GEC/ED IR Responses to Enbridge Gas Inc. (numbering corrected)

N.M9.EGI-86

Figure 1: Quebec Decarbonization Study, Forecast Change in Residential Heating Fuel Mix¹⁵

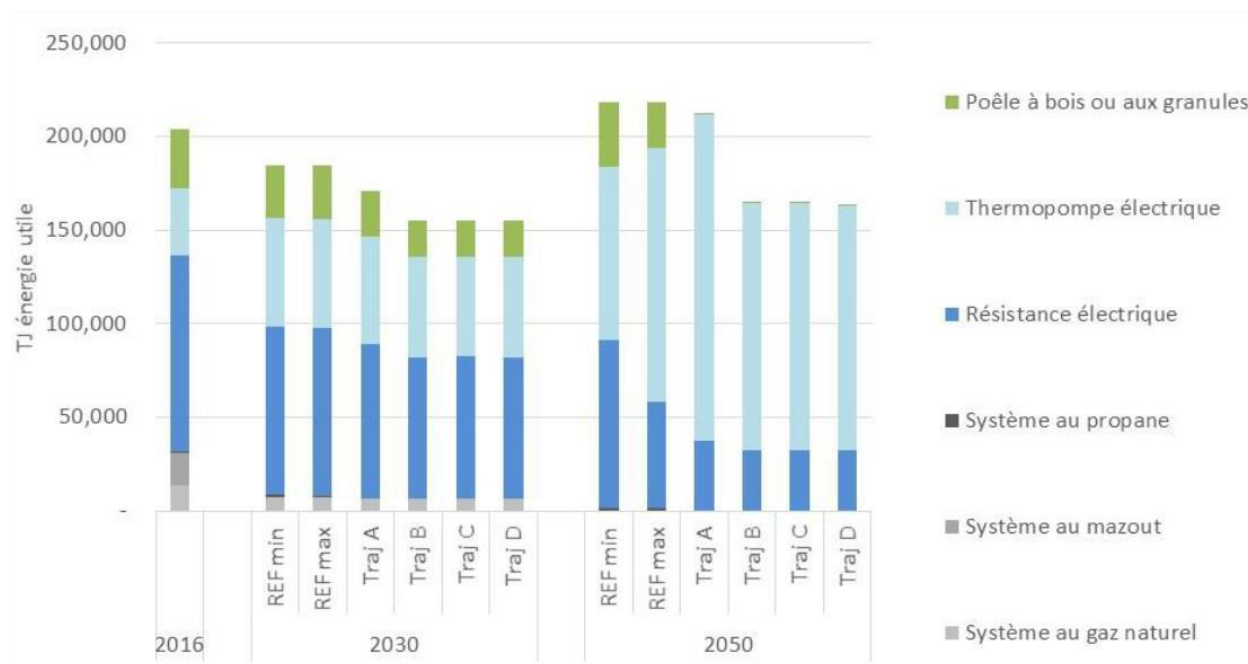
- Please provide English translations of each energy type for Figure 1.
- Please confirm that the vast majority of residential space heating in Quebec is currently provided by electricity.
- Please confirm that the replacement of electric heating with gaseous heating (including hydrogen) was not considered in the Dunsky report due to the significant existing penetration of electric residential space heating.

a) Translations are as follows:

- i. “poele a bois ou aux granules” = wood or pellet stove
- ii. “Thermopompe electrique” = electric heat pump
- iii. “Resistance electrique” = electric resistance
- iv. “systeme au propane” = propane system
- v. “systeme au mazout” = fuel oil system
- vi. “systeme au gaz naturel = natural gas system

b) Confirmed.

c) Not confirmed. It is my understanding that the Dunskey study considered both RNG and hydrogen blending with RNG as an option for all customers. The model used for the study allowed for fuel-switching both from gas to electricity and from electricity to gas. The model simply did not find electric to gas conversions to be economically optimal.³⁰

Figure 2: Quebec Decarbonization Study, Commercial and Institutional Buildings Heating Fuel Mix¹⁷

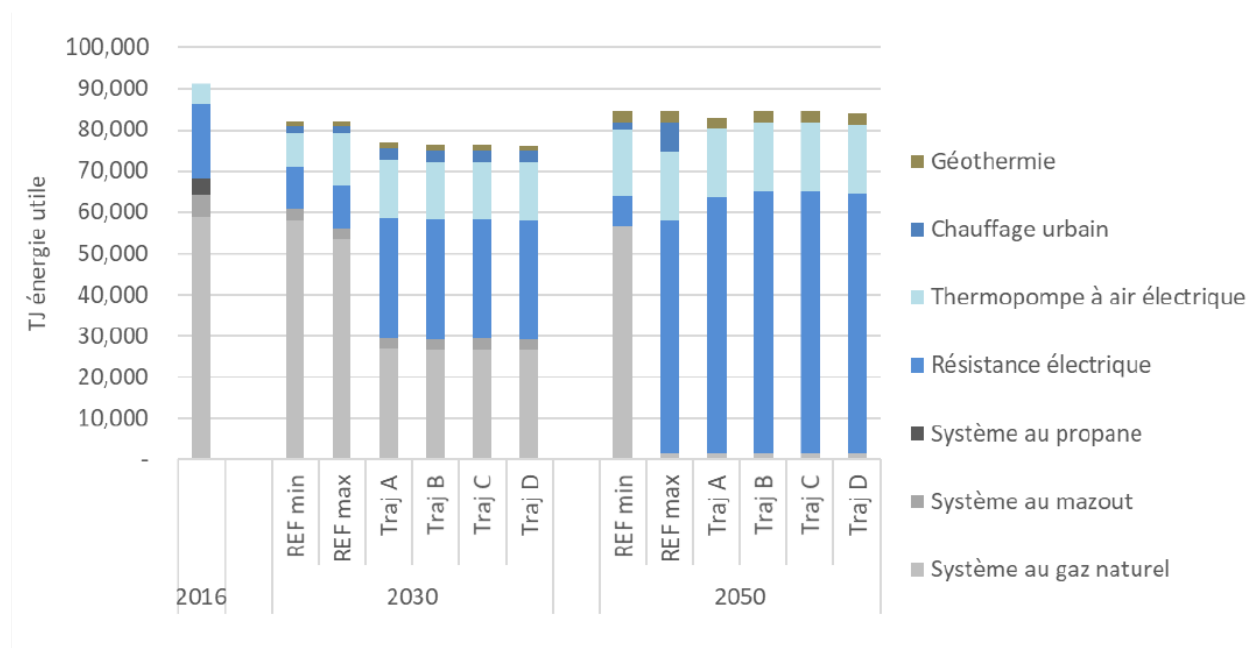
- Please provide English translations of each energy type for Figure 2.
- Please confirm that the Dunsky report projects that the vast majority of commercial space heating in Quebec will be electric resistance heating and that air-source and ground-source heat pumps have a limited role in commercial space heating by 2050.

- Translations are as follows:
 - “géothermie” = geothermal
 - “chauffage urbain” = district heating
 - “thermopompe a air electrique” = electric air source heat pump
 - “resistance electrique” = electric resistance

- v. "systeme au propane" = propane system
 - vi. "systeme au mazout" = fuel oil system
 - vii. "systeme au gaz naturel" = natural gas system
- b) Approximately three-quarters of commercial space heating is forecast to be electric resistance, with the balance being some form of heat pump heating.
